G3NO-2008-00010

DOCKET: No. 52-024

SUBJECT: Responses to NRC Requests for Additional Information, Letter No. 08
(GG3 COLA)

REFERENCE: NRC Letter to Entergy Nuclear, *Request for Additional Information
Letter No. 08 Related to the SRP Sections 11.2, 11.3, 11.4 and 11.5 for
the Grand Gulf Combined License Application*, dated October 6, 2008
(ADAMS Accession No. ML082800238).

Figure 9.2-202. Sanitary Waste Discharge System Simplified Diagram

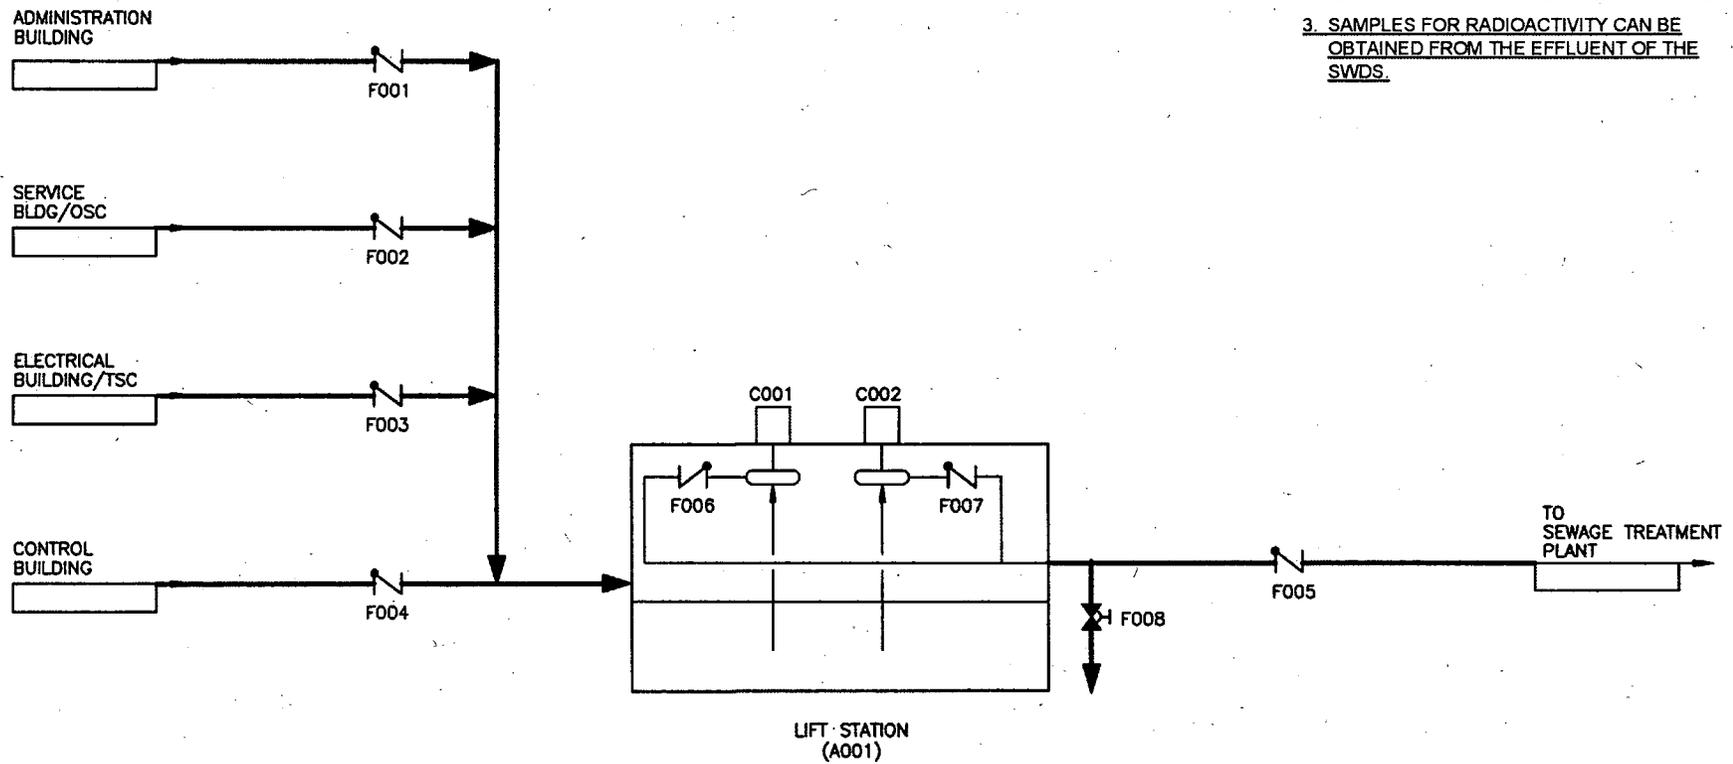
Rather, the capability to obtain and analyze grab samples from the STP in the SWDS complies with IE Bulletin 80-10. Sanitary waste systems are specifically identified in IE Bulletin 80-10 as a type of system for which special consideration should be given. Appropriate sections of the FSAR will be revised to reflect a routine sampling and analysis program for the SWDS effluent in order to identify any contaminating events which could lead to unmonitored, uncontrolled liquid radioactive releases to the environment. In the unlikely event that the SWDS would become contaminated, periodic grab samples obtained from the SWDS effluent would provide the defense in depth protection needed for detection of such contamination. In the event radioactivity is detected above predetermined limits, controls are in place to prevent unmonitored, uncontrolled radioactive releases to the environment.

Accordingly, FSAR Section 9.2.4 and Figure 9.2-202 will be revised to address grab sampling provisions.

In addition, FSAR Section 9.2.4.2 and Figure 9.2-202 will be revised to address grab sampling provisions.

aeration chamber. The effluent is discharged to Stream A. For meeting the action required by NRC Inspection and Enforcement Bulletin No. 80-10, routine sampling and analysis will be performed for the SWDS by obtaining grab samples from the SWDS effluent. The samples provide the means to identify events which could contaminate the environment. The quality of effluent meets, as a minimum, the standards established by federal, state, and local regulations and permits. The ~~sewage treatment plant~~ STP is shared with Unit 1. A simplified diagram of the SWDS is shown in Figure 9.2-202.
